4328 Brooklyn Ave NE

Recommendation Meeting

SDCI: 3036008-LU

February 28, 2022

Appendix: Priorities & Board Recommendations -Massing & Materials (west facade)

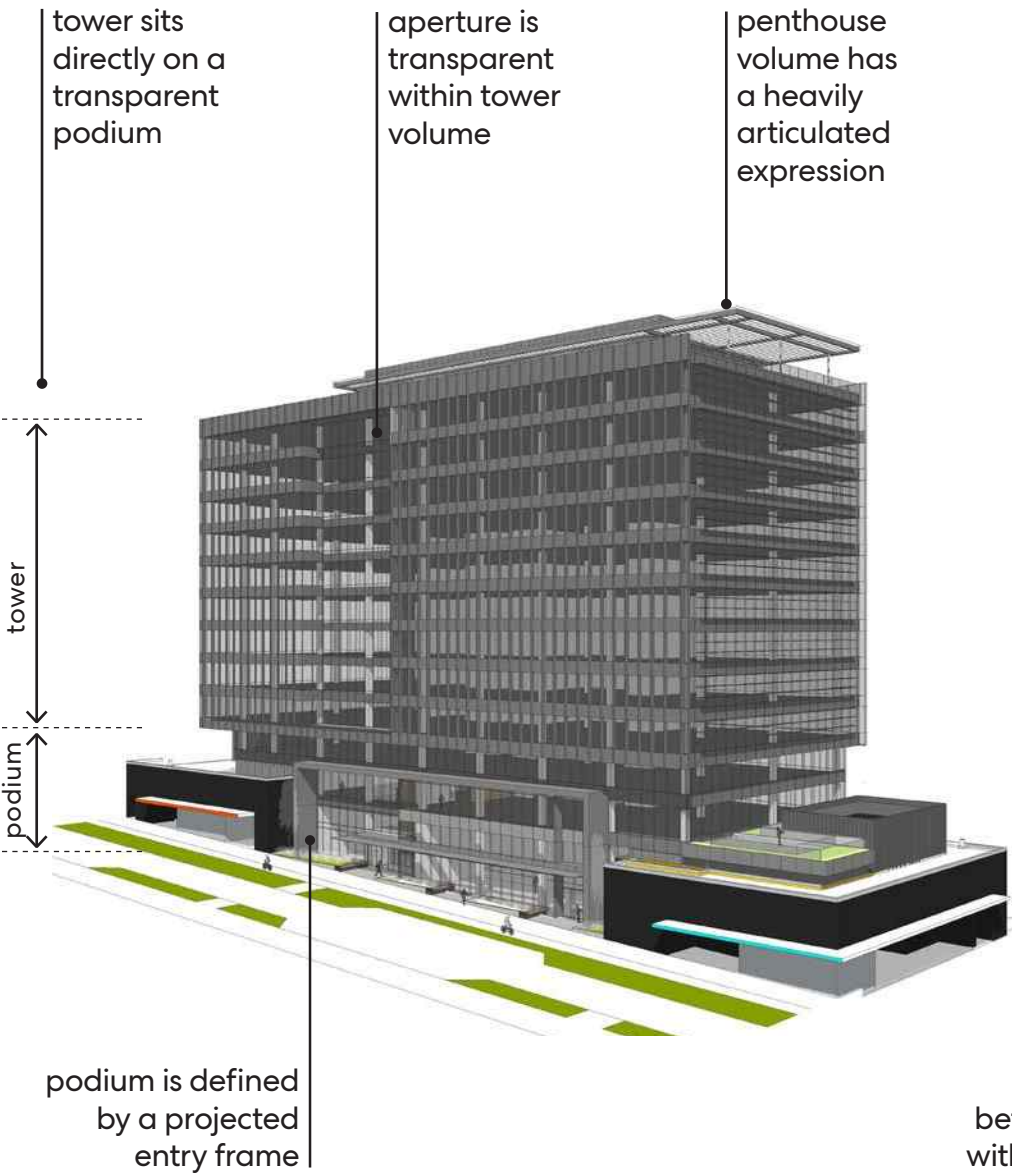
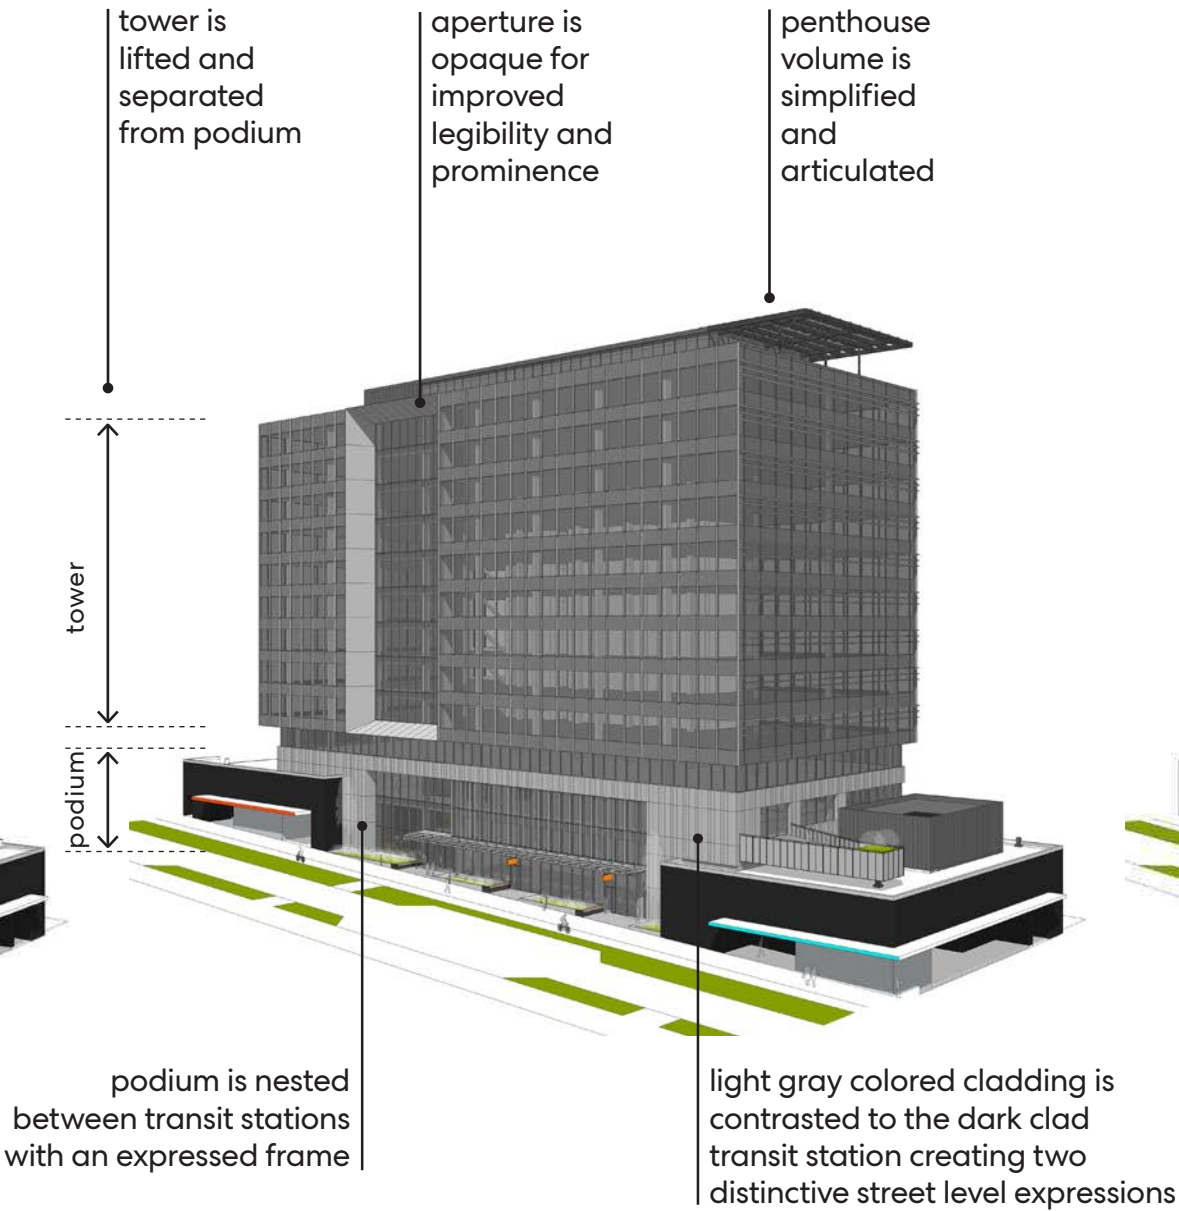
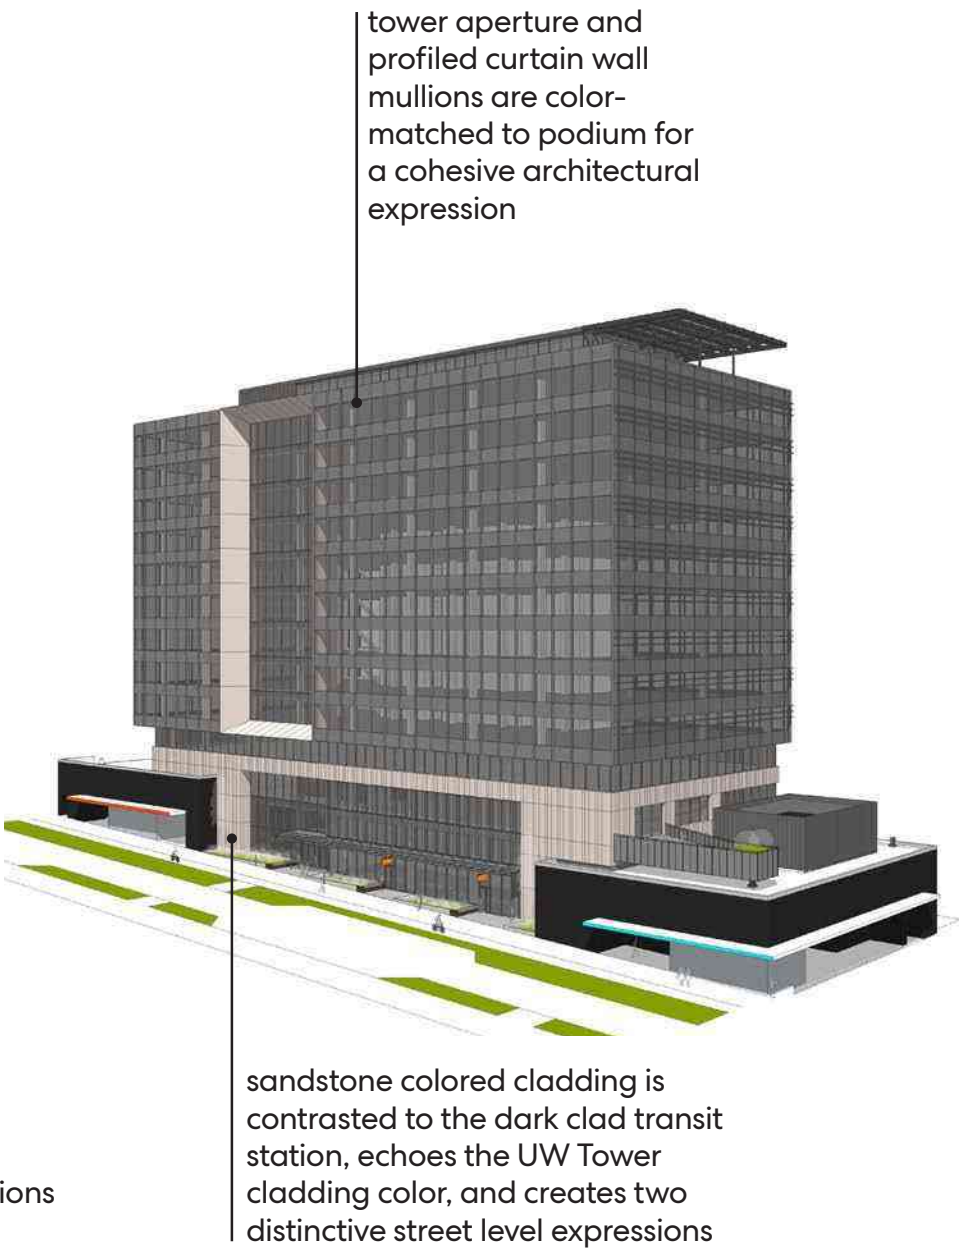
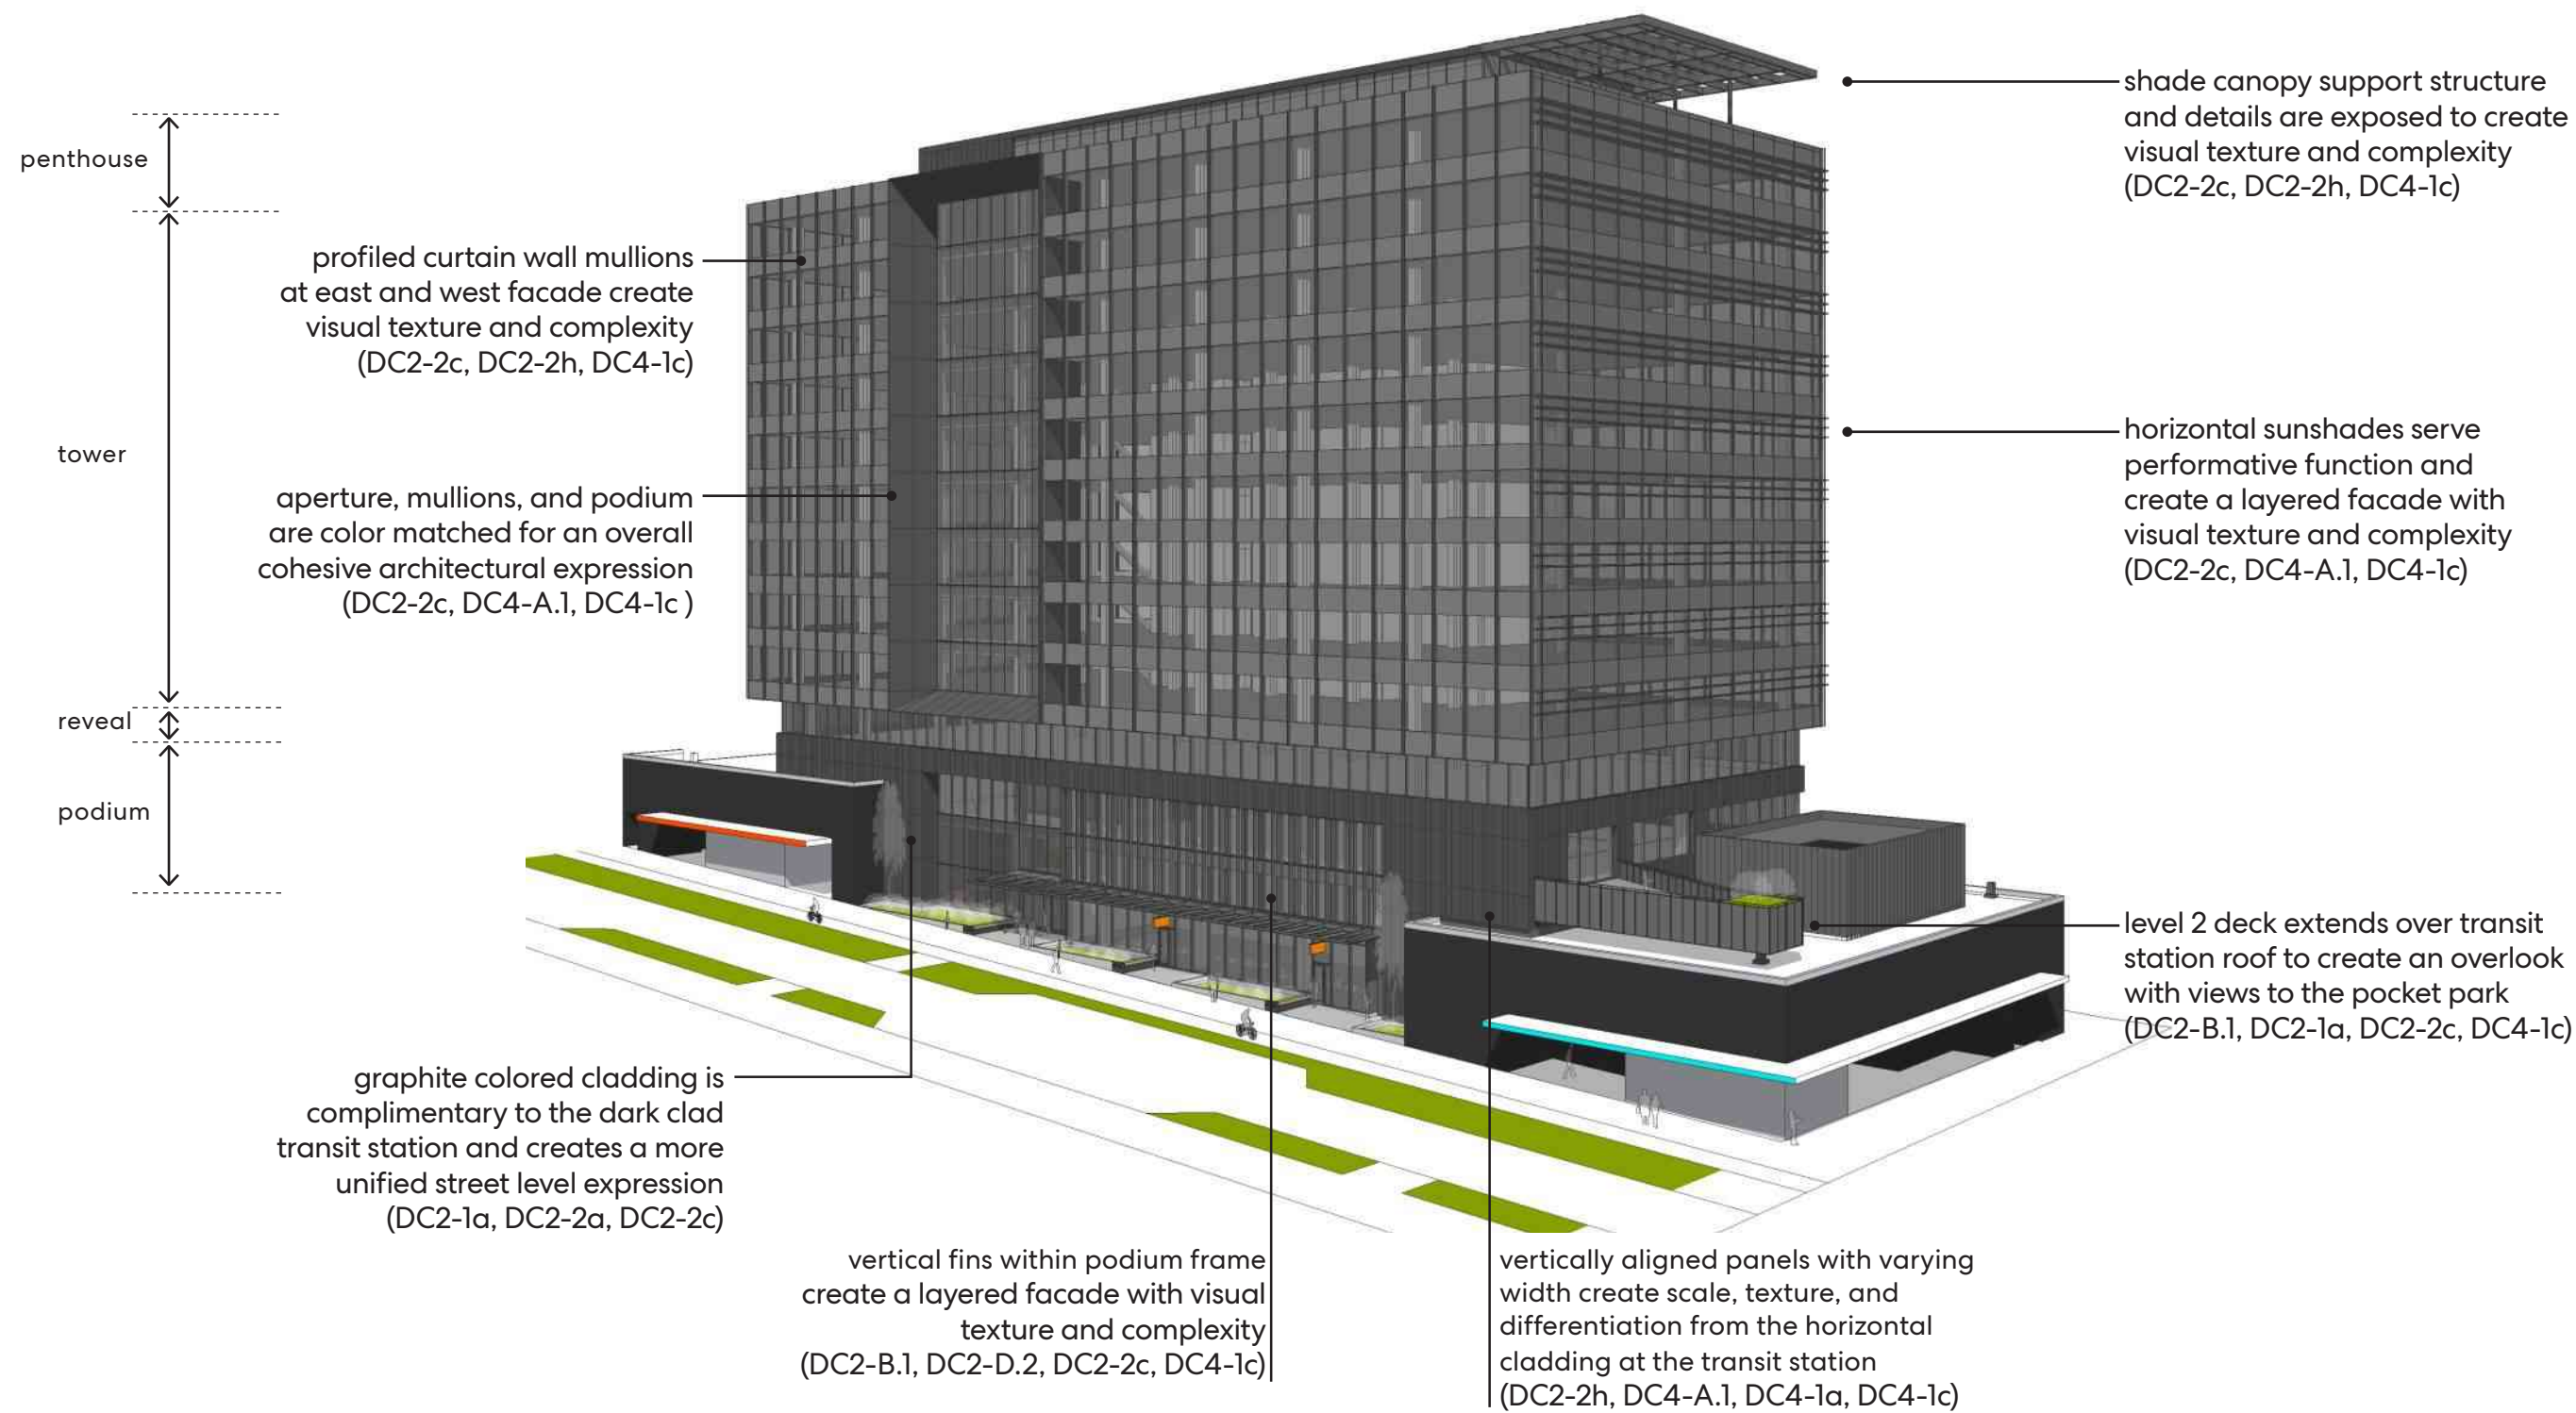
1c) Show work for material application options

The design team explored a number of alternative approaches for translating the massing concept into a clear and legible composition with a cohesive architectural expression (CS2-A.2, PL3-1a, DC2-B.1, DC2-D.2, DC2-2c, DC4-1c)
